CIMARRON CORPORATION

South Uranium Yard Decontamination

May 31, 1995 letter from Mr. Michael F. Weber to Mr. Jess Larsen

The purpose of this letter is to provide responses to the two issues identified in the above-referenced letter. The two issues were raised as a result of the April 24 and 25, 1995 ORISE confirmatory survey of the south uranium yard area located on the Cimarron site.

Figure 1

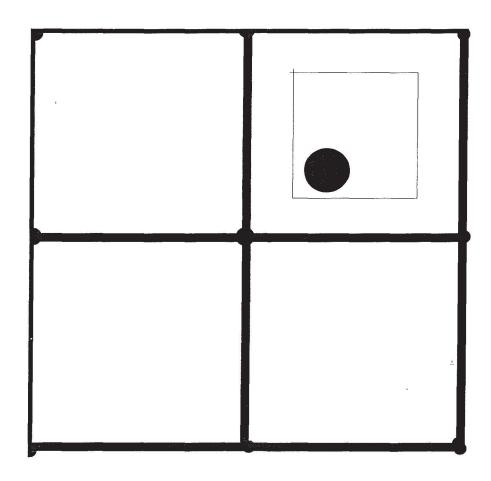
NRC Comment #1: First, the ORISE borehole sample from location #1 (see Enclosure 1), at the 0-15 cm depth, indicated a total uranium concentration of 38.4 pCi/g. Since 38.4 pCi/g exceeds the enriched uranium limit of 30 pCi/g, additional samples should be collected to determine compliance with the hot-spot limit using the procedure that was applied in the November 1994 "Report on the South Yard Remediation at the Cimarron Facility," (South Yard Report). NRC believes that it would be more efficient for Kerr-McGee to collect and analyze the additional samples as opposed to sending ORISE back to the Cimarron site to perform the work. The results of the additional samples should be submitted to NRC.

Response: Cimarron has performed additional gamma scans of the area surrounding the 38.4 pCi/g hot-spot identified by ORISE. These scans were performed using a 3" x 0.5" lead shielded sodium iodide detector. The surface gamma scan indicated that the area of the hot-spot was defined by a 3m x 3m boundary for a total of 9m². The 38.4 pCi/g hot-spot area and the 100m² area used to determine compliance with the NUREG/CR-5849 hot-spot averaging criteria are shown in Figure 1.

The 100m^2 area containing the 38.4 pCi/g hot-spot was evaluated based upon the criteria in NUREG/CR-5849. The hot-spot is less than three times the soil guideline value of 30 pCi/g total uranium. In addition, the calculation presented below shows that the average concentration is less than $(100/\text{A})^{1/2}$ times the guideline value of 30 pCi/g.

38.4 pCi/g < (30)
$$(100/A)^{1/2}$$
 = (30) $(100/9)^{1/2}$ = 100 pCi/g

The average activity in the 100m^2 contiguous area containing the hot-spot was also determined. NUREG/CR-5849 specifies that the average activity in the 100m^2 area must be less than or equal to the guideline value (≤ 30 pCi/g). This calculation is performed using the ORISE hot-spot data and the Cimarron characterization data.

$$\bar{x}_{w}$$
= 16.6 [1 - (9/100)] + 38.4 [9/100] = 18.6 pCi/g
18.6 pCi/g \leq 30 pCi/g

All criteria in NUREG/CR-5849 have been satisfactorily met. Therefore, the hot-spot identified by ORISE will not affect the conclusion that the South Uranium Yard meets all release criteria.

FIGURE 1
ORISE BACKGROUND SOIL SAMPLING LOCATIONS

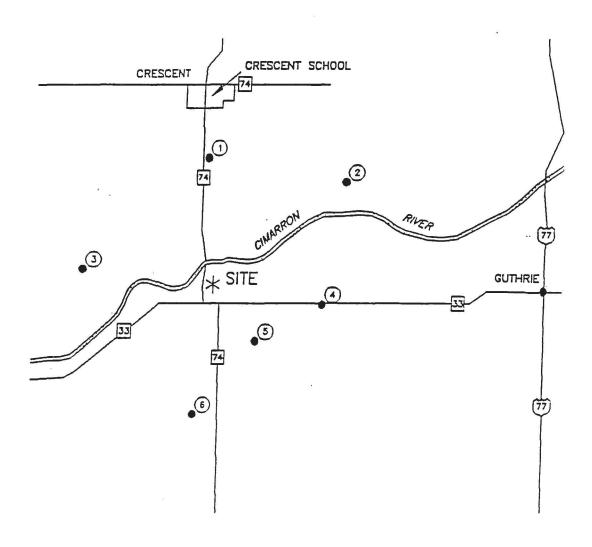
NRC Comment #2: Second, during the confirmatory survey, ORISE collected six samples from the vicinity of the Cimarron site to assess background uranium concentrations. The ORISE results for background concentrations of total uranium range from 0.80 to 1.86 pCi/g. These values differ from the background concentration of 6 pCi/g total uranium reported in the South Yard Report (page 4). Please provide an explanation for this apparent discrepancy.

ORAU prepared a report, "Confirmatory Radiological Survey Former Burial Ground Cimarron Corporation Facility Crescent, Oklahoma, July, 1992", which included analysis of six background soil samples collected near the Cimarron facility. The sampling locations are shown in Figure 1. Table 1 summarizes the total uranium data from the ORAU report. Total uranium in the six background soil samples ranged from less than 1.2 pCi/g to 2.0 pCi/g, based upon calculations performed using the gamma spectroscopy data. The average concentration for the samples, assuming that the actual concentration for the two reported "less than" values are equal to the maximum possible values, was reported as 1.6 pCi/g.
